Re: Property Owner Letter of Authorization

The purpose of this letter is to request the approval of a Minor Amendment to the approved Site Plan at 6600 Gulton Court NE (PR-2020-004708) for the Explore Academy Charter School. The approved Site Plan features a gymnasium/classroom addition 16,450 square feet in size. The proposed Minor Amendment shows the addition at 21,779 square feet increasing the overall building's square footage by 5,329 square feet (5.5%). Additionally, the requested amendment is seeking to redesign a small sport court located near the southeast corner of the gym/classroom addition into a large chessboard. The sport court is displayed as keynote 33 on the approved Site Plan.

PROJECT NAME EXPLORE ACADEMY

GYMNASIUM ADDITION

SDP1.1A

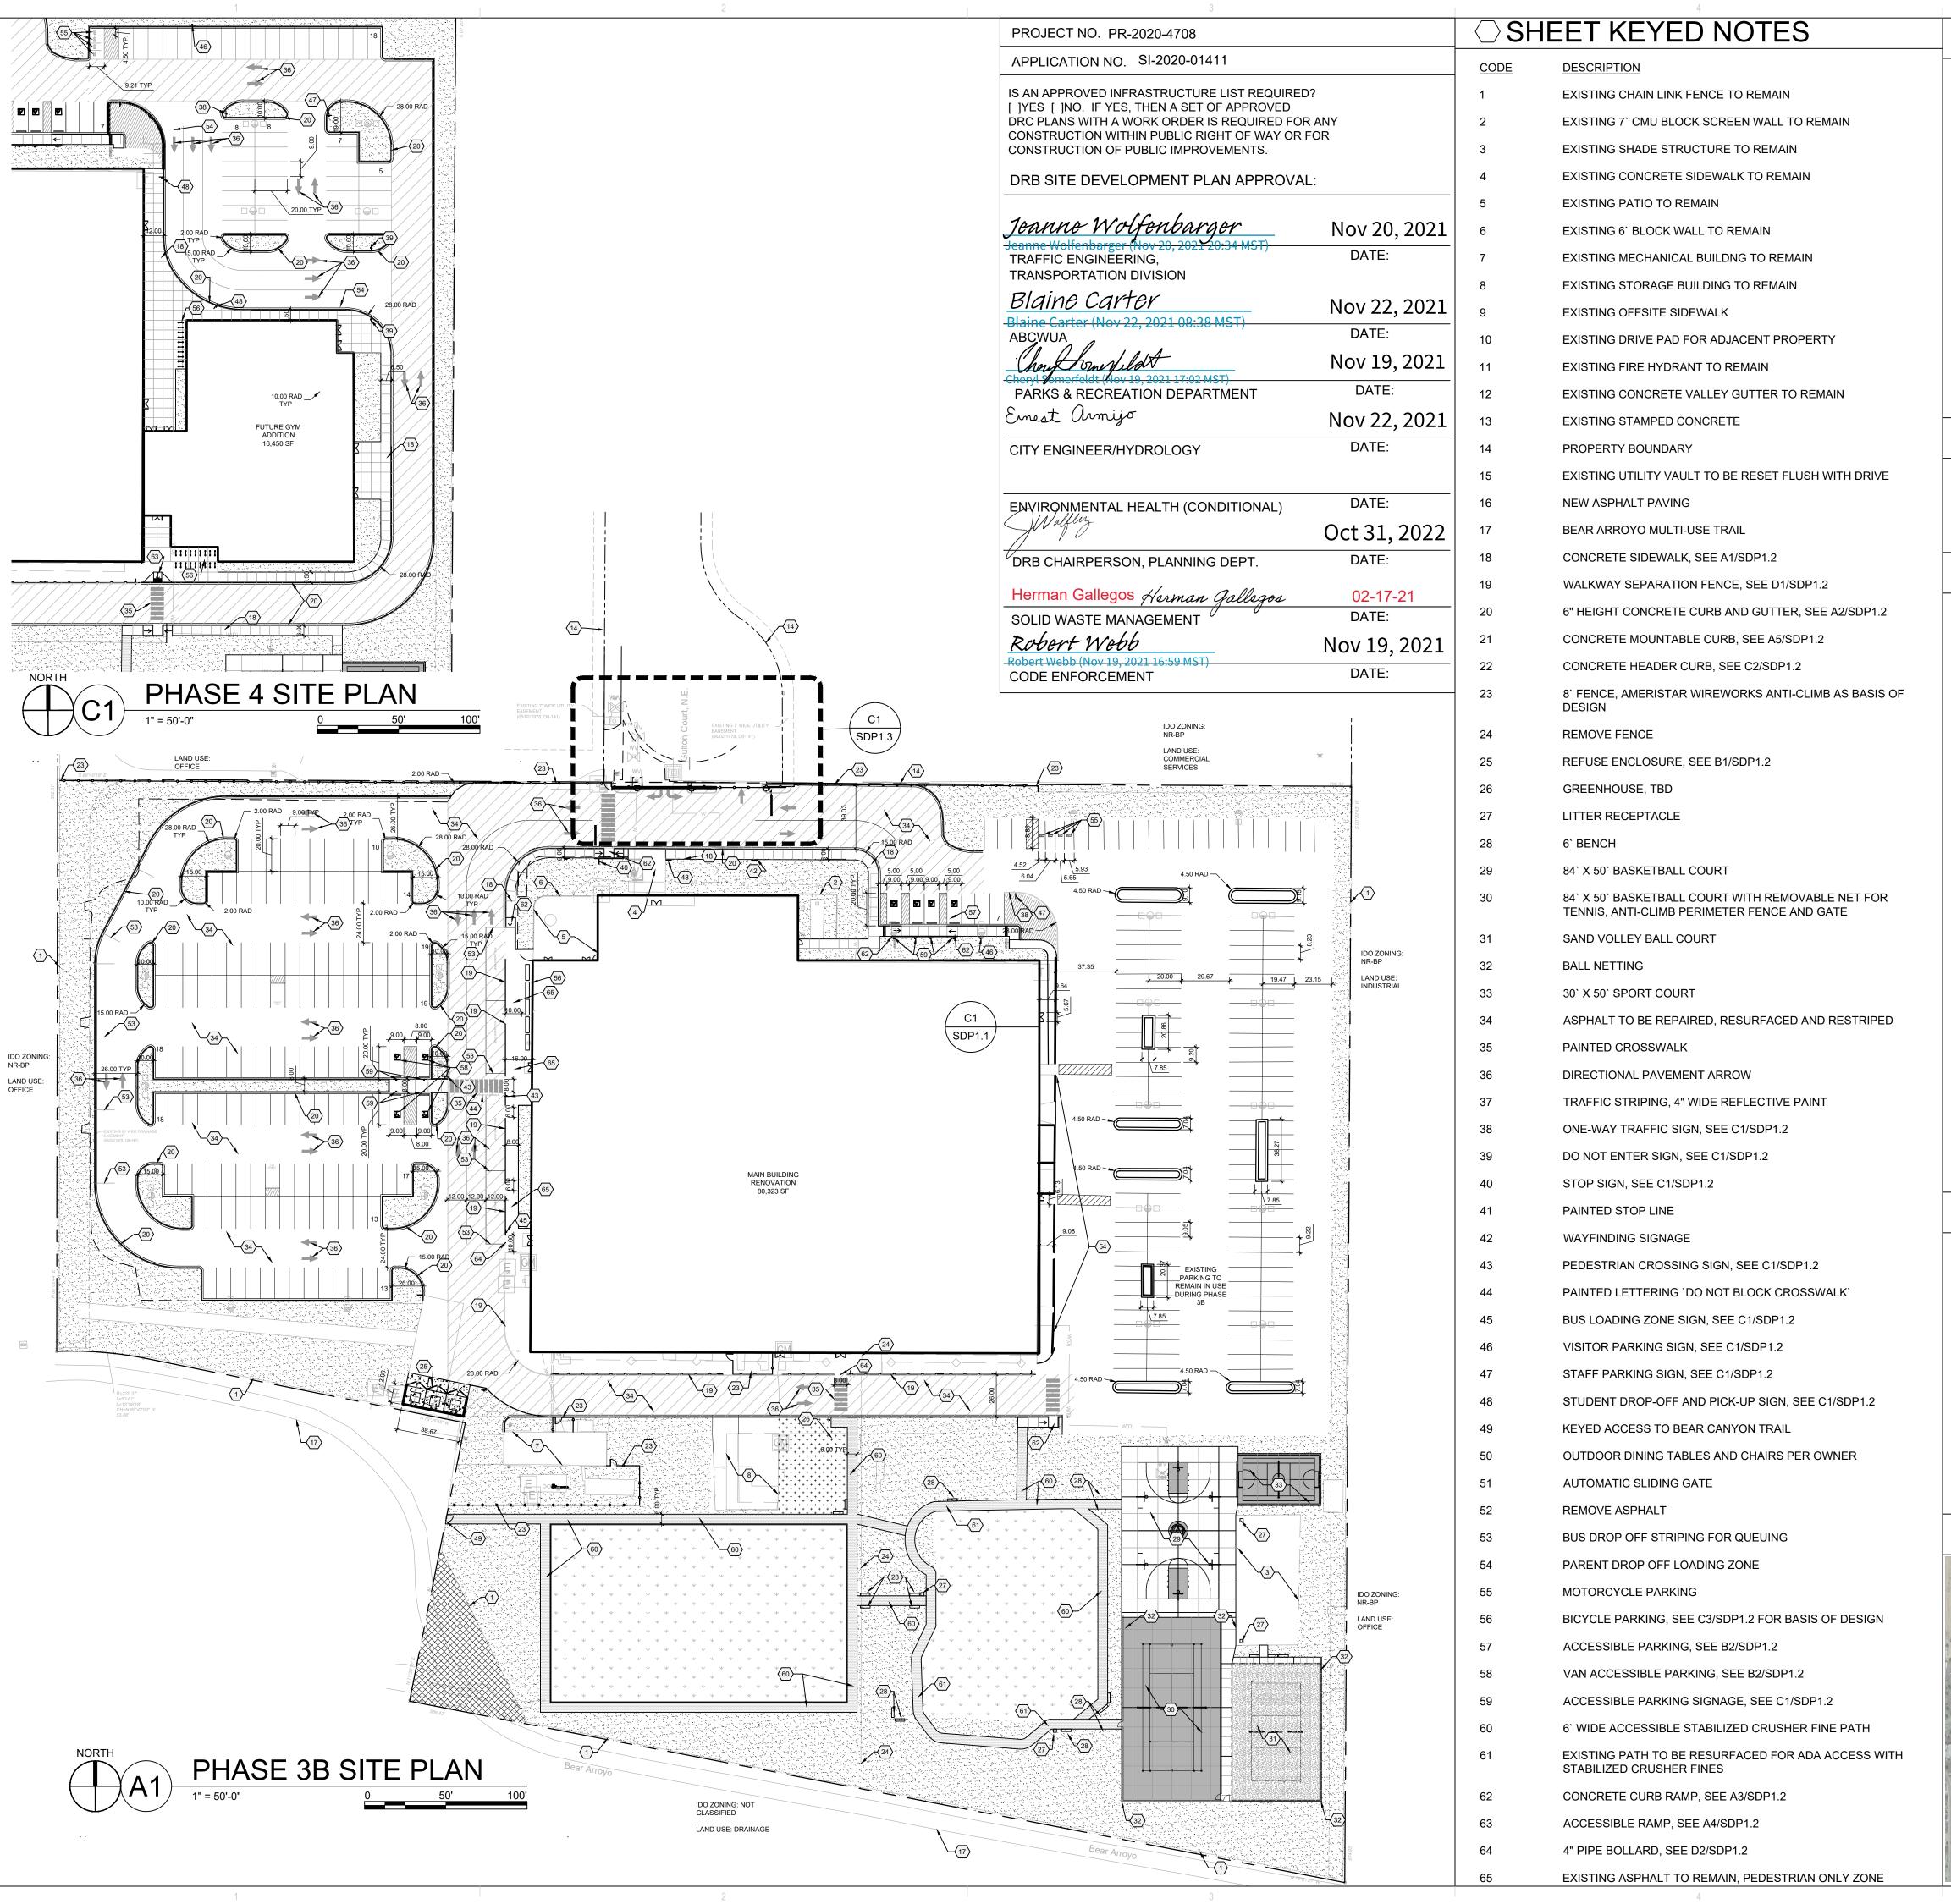
Applicant Response: This request does not increase or decrease the dimension of any standard beyond the allowable threshold for a Minor Amendment pursuant to Table 6-4-4. The approved Site Plan indicated the gymnasium/classroom addition would be 16,450 square feet and the requested amendment is seeking to increase the square footage by 5,456 square feet for a total of 21,906 square feet. The previously approved

total building square footage was 96,952 square feet and the new proposed total building square footage is 102,086 square feet, 5.5% increase in square feet.

The increase in the size of the gym does not impact the number of students or school employees. The increase is based on providing a better-equipped facility to serve the students. The proposed redesign of the sport court to create a chess board will not affect any standards in Table 6-4-4.

LANDSCAPE CALCULATIONS REFLECT COMPLETION OF PHASE 4 APPROVED LANDSCAPE AREA = 105,023 SF = 31% REVISED LANDSCAPE AREA = 104,979 SF = 31%

REQUIRED VEGETATIVE COVERAGE
REQUIRED VEGETATIVE COVERAGE = 78,767 SF = 75% OF PROVIDED LANDSCAPE AREA
"A MINIMUM 25% REQUIRED VEGETATIVE COVERAGE BY GROUND PLANTS"
REVISED TOTAL VEGETATIVE COVERAGE = 79,100 SF = 75.5% OF REVISED LANDSCAPE AREA
REVISED TREE CANOPY COVERAGE = 59.140 SF REVISED GROUND PLANT COVERAGE = 19,959 SF = 25% OF REQUIRED VEGETATIVE COVERAGE

GROUND COVER MATERIAL TOTAL ROCK MULCH GROUND COVER = 33,897 SF = 52% TOTAL ORGANIC MULCH GROUND COVER = 30,690 SF = 48%
